Mount Owen Continued Operations Project Application Modification 2 (No. SSD 5850 MOD 2) Response to Submissions – request for additional information

Table 1 – Mount Owen Continued Operations Modification 2 - Response to Submissions

Mount Owen Continued Operations Modification 2		
DPE – request for further information in relation to SEE.		
Aspect	DPE Request	Response
Groundwater	In Figure 4-2 of the Groundwater Impact Assessment (and Figure 3.2 of the SEE), why are Integra Underground longwalls marked as forming part of the proposed modification?	The Integra Underground longwalls do not form part of the Proposed Modification. The Proposed Modification is annotated with pink hatching on Figure 3.2 , the figure has now been amended to remove the pink dotted lines from the Integra Underground longwalls to avoid confusion. The revised version of Figure 3.2 is attached.
	For comparison purposes, how do the modelled years (Years 1 to 19) in Section 7.1 of the Groundwater Impact Assessment relate to those in Section 3.5.2 of the Jacobs assessment from the EIS?	<p>The modelling results are not directly comparable.</p> <p>As discussed in the groundwater impact assessment (GWIA) and the SEE

FIGURE 1
Additional Water Monitoring

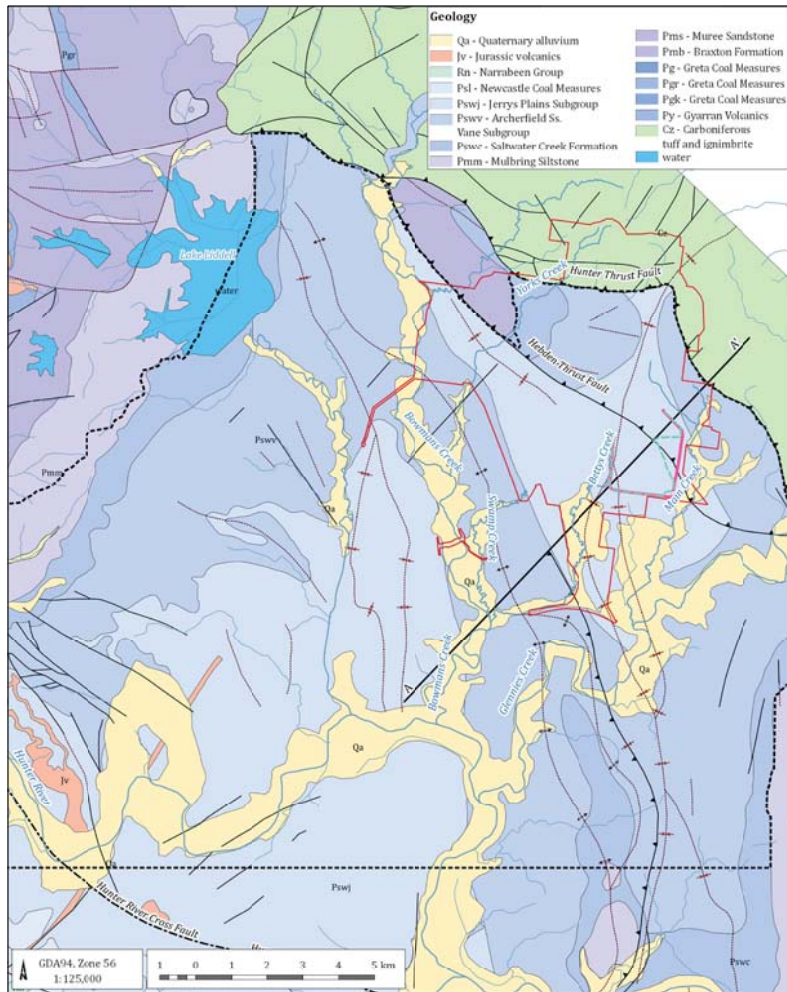
Is Glencore proposing to implement all of the recommendations of the Geochemical Assessment, including the additional monitoring locations/frequency/parameters? If so, could we please have a figure which shows where those additional monitoring sites will be located (ie ECD2, West Pit decant, North Pit dewatering)?	<p>As discussed in Section 6.5.5 of the SEE, the Mount Owen Surface Water Management and Monitoring Plan (SWMMP) will be updated to include water quality monitoring provisions to monitor for ARD effects, in accordance with the recommendations from the Geochemistry Assessment.</p> <p>Monitoring will be undertaken at the ECD dam (see Figure 1), a sample will be taken directly from the ECD dam. West Pit Decant and North Pit Dewatering will also be sampled at the ECD dam at the pipe outlets prior to the water entering the ECD dam.</p>
Noise	<p>While the RTS provides further justification for the noise assessment methodology, it does not provide any further explanation regarding the optimised scenarios. Specifically, it is still unclear which control options were applied in order to achieve compliance with the noise criteria. Page 37 of the RTS states:</p> <p>‘It should also be noted that the maximum level of control required to meet the existing noise criteria at each of the receiver locations.... is only required for the worst case meteorological conditions that are applicable according to the definitions in Appendix 4...’</p> <p>It is not clear what the ‘maximum level of control’ entailed under each scenario. The Department recognises that Glencore requires flexibility to select the most appropriate combination of noise controls at any one time, based on conditions and operational demands. However, the assessment should be transparent about how compliance with the noise criteria was achieved under each of the modelled scenarios.</p>	<p>A detailed response to the information requested is provided in Appendix 3.</p> <p>Receiver location 133 was incorrectly identified as a residence in the original EIS, there are some vacant outbuildings located on the property however there is no residence.</p>

FIGURE 2

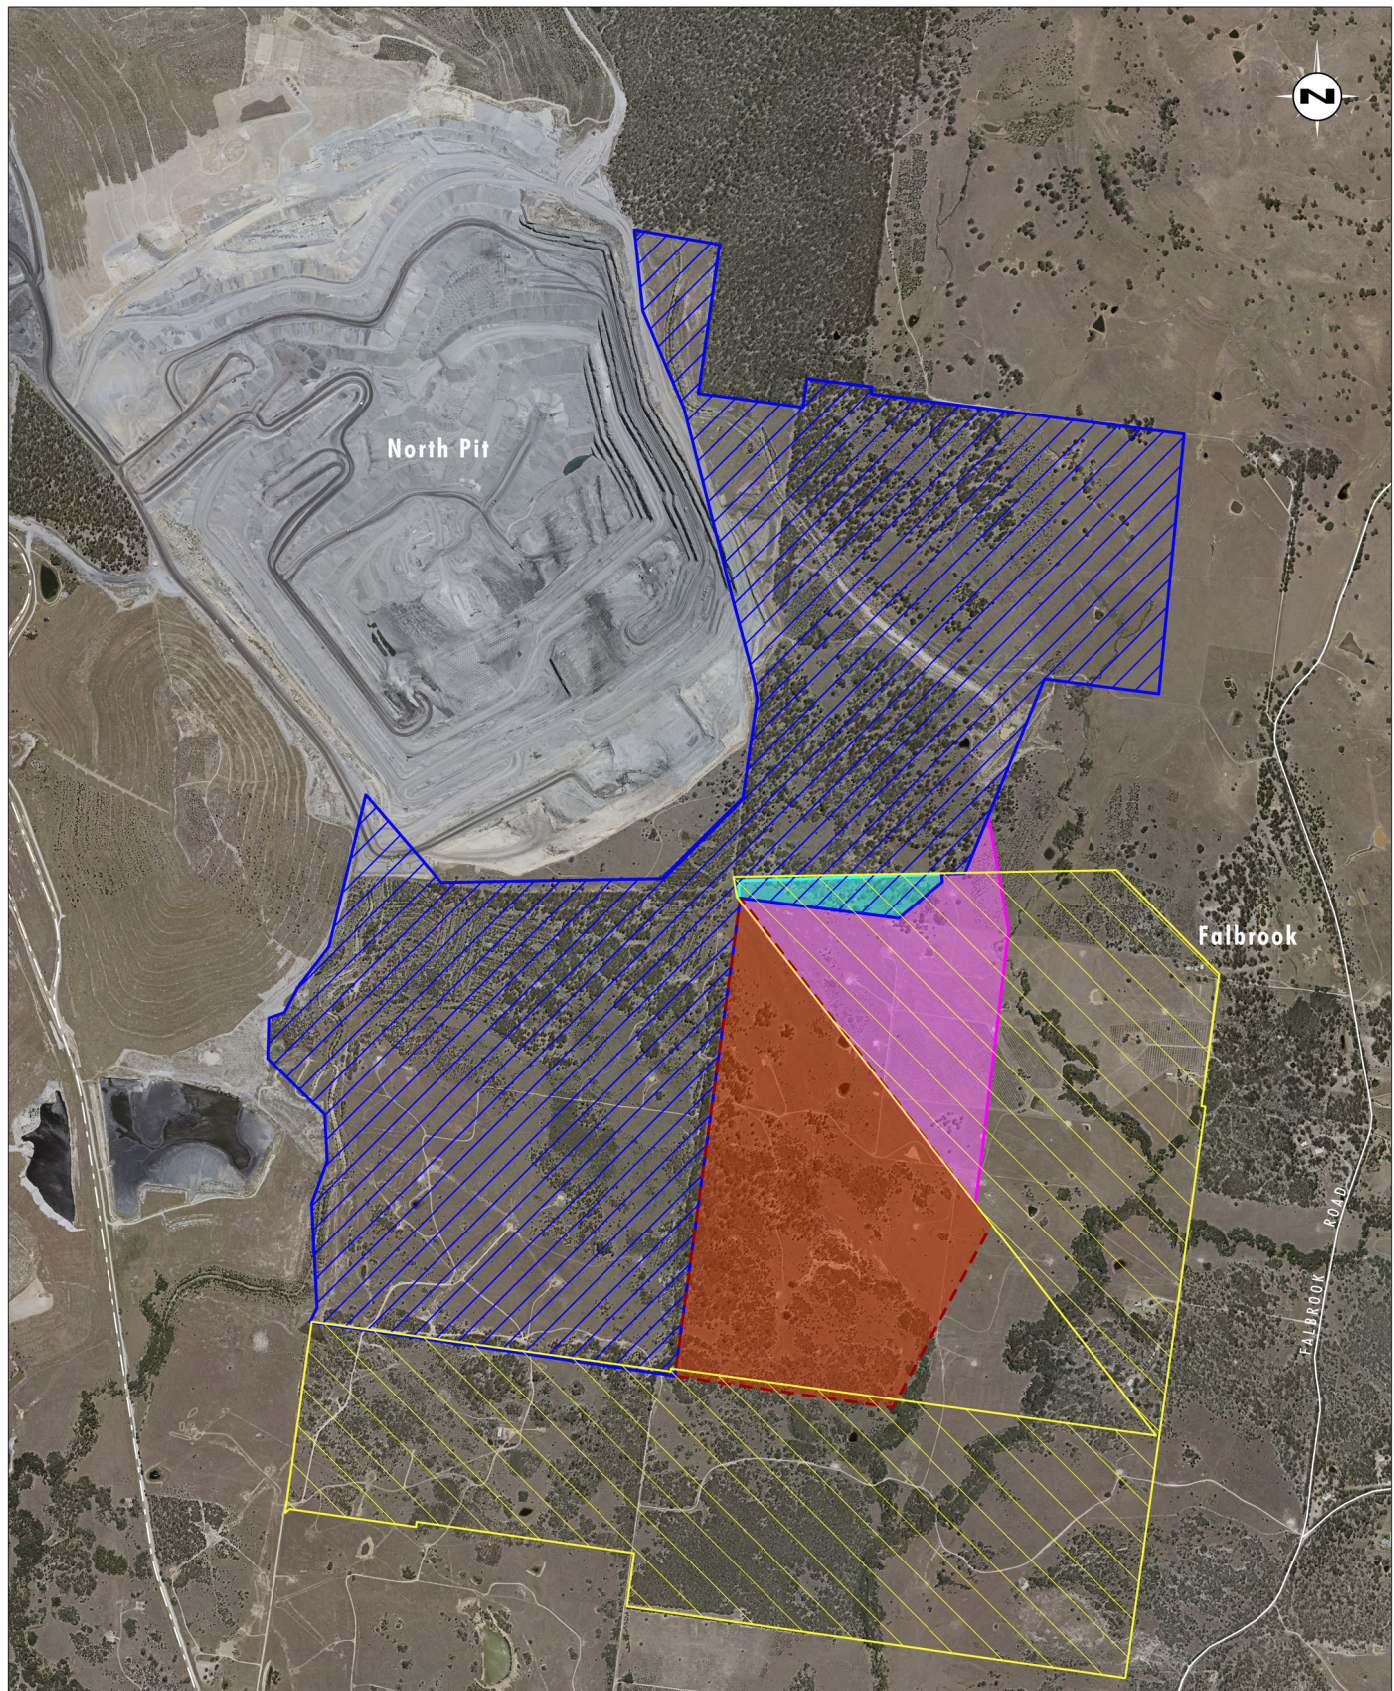
Mount Owen Continued Operations Modification 2		
DPE – request for further information in relation to SEE.		
Aspect	DPE Request	Response
	This area was not covered under the SVC for MOD 2, or the original SVC for SSD 5850. Can you confirm why this area was excluded?	<p>question was inadvertently excluded (refer to Figure 2).</p> <p>A mining lease is required over the area identified as part of the Proposed Modification. In order to address this issue, Mount Owen has submitted a SVC application for this area. This is considered to be an administrative issue as the area does not meet the BSAL criteria. The area in question is <20 hectares (approximately 7.4 hectares), with approximately half the area subject to areas >10 % slope and directly adjoins a large area verified as not containing BSAL.</p>
